SERVICE BULLETIN

No. Q1010 under BRAKES

MANDATORY SAFETY CAMPAIGN

BRAKE ANTI-WHEEL LOCK WIRING
(R. RD. U and DM with MVSS121 Anti-Lock System)

FIGURE 1
HARNESS CONNECTIONS AT BRAKE CONTROLLER
CORRECT

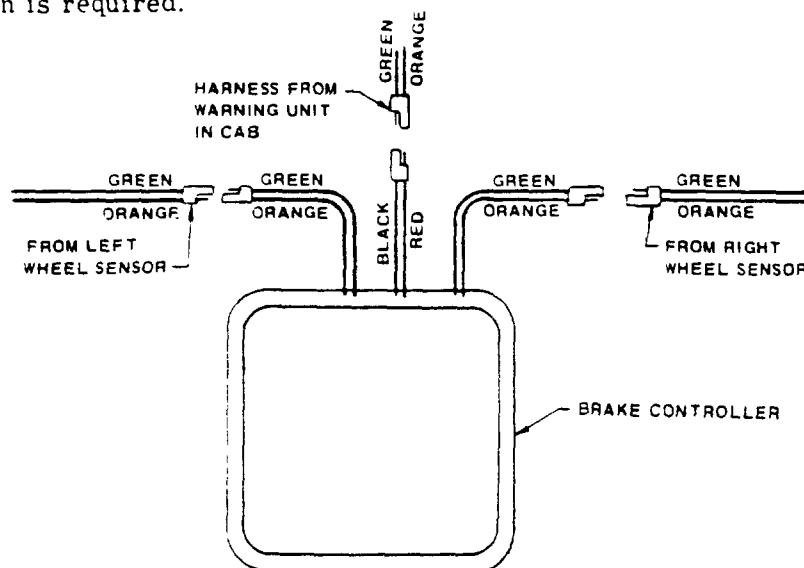
INFORMATION On some vehicles, the wires from cab power/warning harness to front axle controller were connected to one of the controller wheel sensor leads instead of the controller power/warning leads. When connected in this manner, the controller is not powered, resulting in loss of anti-wheel lock capability on the front brakes and failure of the warning light to indicate this malfunction. Under this condition, the front brakes operate in the fail-safe mode, but without anti lock control and therefore could lock during a panic stop.

Check wiring color coding at the harness connections at front axle controller. If they are as shown in Figure 1, no further inspection or correction is required.

1. QUICK RELEASE VALVE 20QE 291
2. BRAKE CHAMBERS
3. EXISTING RATIO VALVE
FIGURE 6

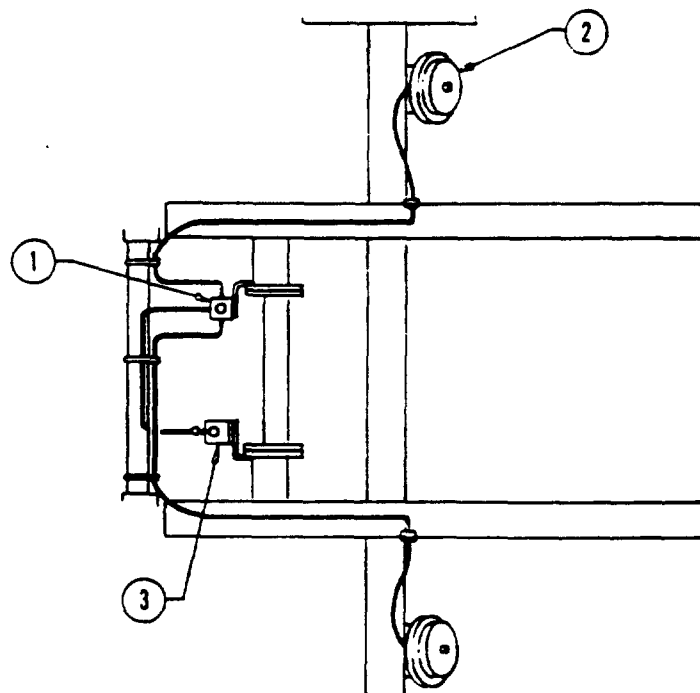
- c. Install quick release valve 20QE291 on engine front support in same location from which the front wheel controller was removed. Mount on bracket shown in parts list using existing fasteners for the bracket and new fasteners for the valve. This valve is required to perform the quick release function formerly provided by the front axle controller.

Pipe the valve as shown in Figure 6. Remove line originally used to connect controller supply port to secondary reservoir and plug tank opening. This line is not required.

FIGURE 7

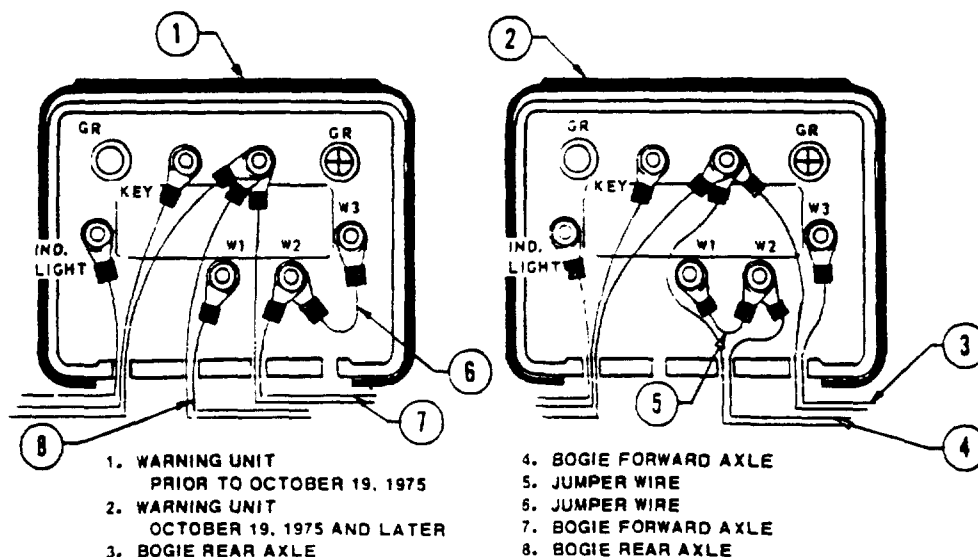
- d. Install a jumper between the front axle terminal and W2 terminal of the failure warning unit located in cab. This step is necessary with removal of the front axle controller, to prevent a false failure indication. See Figure 7.

FIGURE 1
BRACKET INSTALLATION

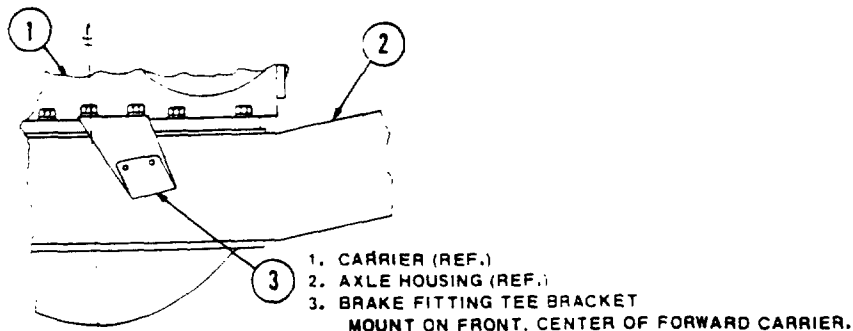
Remove existing tee bracket and install new bracket. The bracket is located on the forward axle carrier and uses the carrier mounting bolts for attachment. See Figure 1. Tighten the attaching bolts 134 to 148 lb. ft. torque at installation of new bracket.

FIGURE 5
PIPING SCHEMATIC - BOGIE CONTROLLER SYSTEM
(TO BE REMOVED)

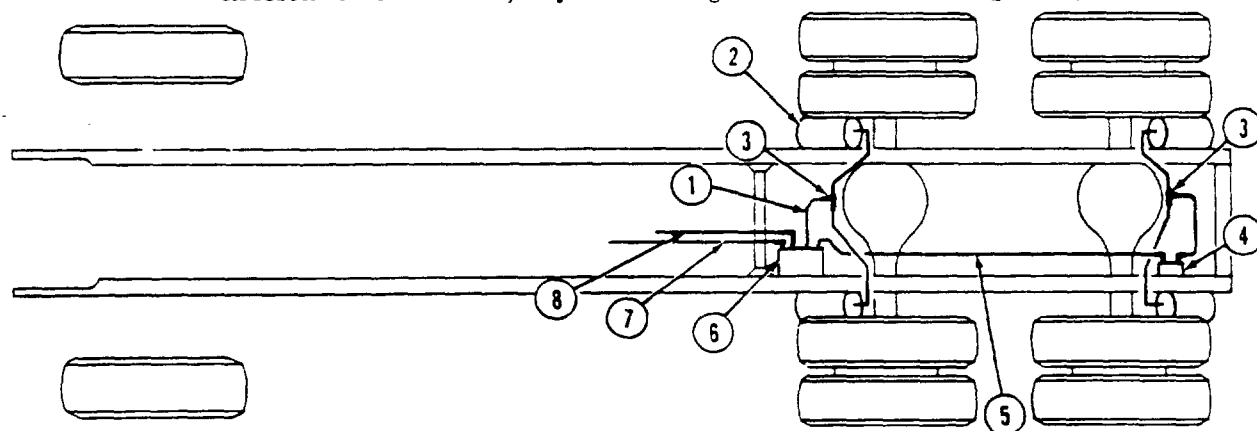
- a. On both systems, remove and discard delivery line manifold fitting. It is mounted on left hand frame rail, adjacent to bogie rear axle. See Figure 5, Item 4.

FIGURE 7
RELAY WIRING DIAGRAM

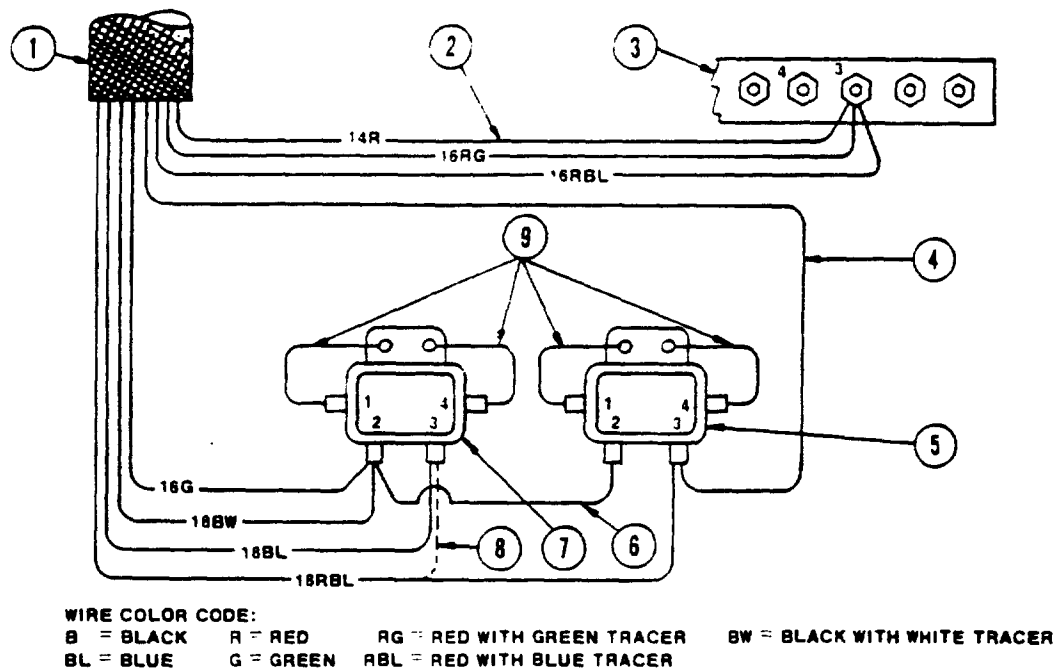
1. CAB WIRING HARNESS
2. THIS WIRE REMOVED PER SERVICE BULLETIN Q1020 UNDER BRAKES. IT MUST BE RECONNECTED TO NO. 3 CIRCUIT BREAKER TERMINAL.
3. CIRCUIT BREAKER STRIP
4. #18 BLACK WIRE - PART OF CAB WIRING HARNESS. THIS WIRE IS NOT USED WITH SINGLE BOGIE CONTROLLER.
5. ADDED WARNING LIGHT RELAY
6. NO. 14 JUMPER WIRE (ADDED)
7. ORIGINAL WARNING LIGHT RELAY
8. REMOVE FROM ORIGINAL RELAY AND CONNECT TO ADDED RELAY
9. GROUND TO MOUNTING SCREWS.

- e. Connect the new relay into the circuit as shown in Figure 7. This includes reconnecting the wire removed per Service Bulletin Q1020 under BRAKES. In addition a jumper wire (14 gage) must be added to connect the No. 2 terminal of original relay to No. 2 terminal of the added relay.

FIGURE 10
CONTINUITY CABLE CONNECTION

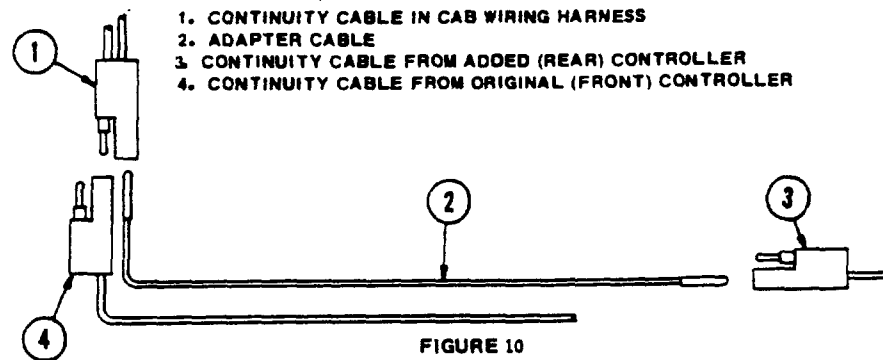
- c. Connect continuity cables as follows: See Figure 10.

Use existing cable for forward controller. Disconnect it from the cab harness (at dash panel), rotate 180 degrees and reconnect it, using male side of cab harness connector. Female side of cab connector is left open.

- d. Run a new continuity cable, 41MR3527-P11 from rear controller forward to the cab harness at dash panel. Note from the illustration that the female side of the new continuity cable is to be connected to the female side of cab harness. To make this connection, it is necessary to fabricate an adapter cable having bullet type connectors at both ends. Make the cable from 14 gage wire (approximately 18 in. long) and two 0.180 diameter, SAE J928 connectors.

FIGURE 11
WHEEL SPEED SENSOR LEAD ROUTING

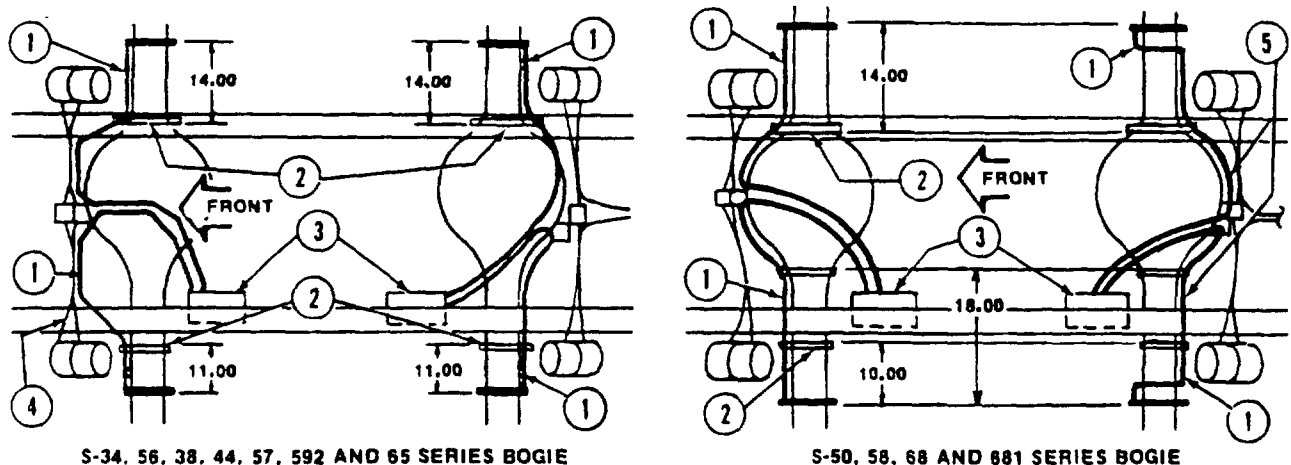
- f. Remove existing wheel speed sensors and replace with the new ones shown in parts list. These sensors have longer leads than original ones, eliminating need for the intermediate sensor harness. The harness should be discarded. Exercise caution when routing and clamping sensor wires to avoid damage caused by relative motion of axle and frame. See Figure 11.

FIGURE 4
INSTALLING ANTI-WHEEL LOCK DISABLING KIT

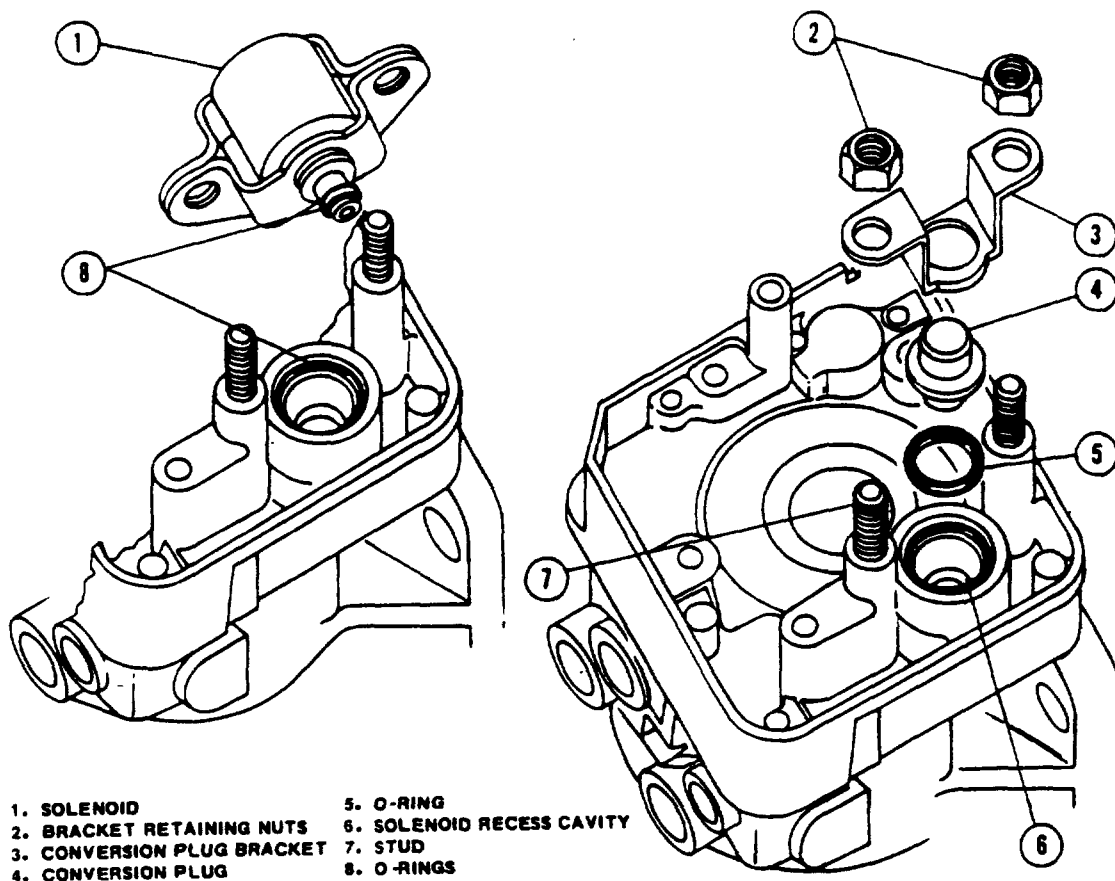
1. After detaching the controller from the air valve assembly, remove the two 5/16 in. nuts (2) using a 1/2" socket or wrench, holding the solenoid on the mounting studs (7). Save the two 5/16 in. nuts for reuse).

2. Carefully remove the solenoid (1) from its stud mounted position by lifting it straight up. If both "O" rings (8) do not come out with the solenoid, inspect the solenoid recess cavity to find them. Remove and discard them along with the solenoid.
